MAPLETON CITY

MAPLETON BIKE PARK

Addendum #1
February 20, 2026

MAPLETON CITY
MAPLETON BIKE PARK
LAYOUT & MATERIALS DETAILS

1 PARK ENTRANCE GATEWAY - DESIGN INTENT ONLY
NTS

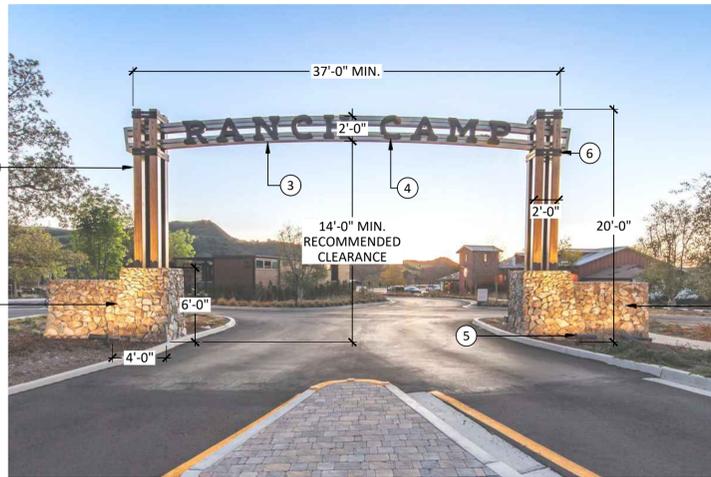
- a. The Park Entrance Gateway detail on LM-507 has been revised to include additional information about material types, approximate sizes, submittal requirements, etc. The revised LM-507 has been attached to this addendum.

GATEWAY SHALL INCLUDE STONE VENEER COLUMNS ONLY. STONE WING WALLS SHALL NOT INCLUDED AS PART OF THE ENTRY GATEWAY.

- ① FOUR (4) 6"x6" POWDER-COATED STEEL POSTS. COLOR TO BE APPROVED BY OWNER. CONTRACTOR TO PROVIDE COLOR SAMPLES.
 - ② 4'x4'x6' STONE VENEER COLUMN, TYP. SIZE AND COLOR TO MATCH PAVILION/RESTROOM BUILDING STONE VENEER.

- ③ POWDER-COATED STEEL ARCHED DOUBLE BEAM. SIZE AS REQUIRED FOR PROPOSED SPAN. COLOR TO BE APPROVED BY OWNER. CONTRACTOR TO PROVIDE COLOR SAMPLES.
 - ④ "MAPLETON BIKE PARK" LETTERING. 2"H X 3" THICK POWDER-COATED ALUMINUM. COLOR TO BE BLACK. ATTACH TO ARCHED DOUBLE BEAM BY WELD OR FASTENERS.

- ⑤ ENSURE STONE BASES ALLOW FOR INTEGRATED ACCENT LIGHTING, COORDINATE WITH OWNER.
 - ⑥ POWDER-COATED BLACK STEEL STRUCTURAL HARDWARE, TYP.
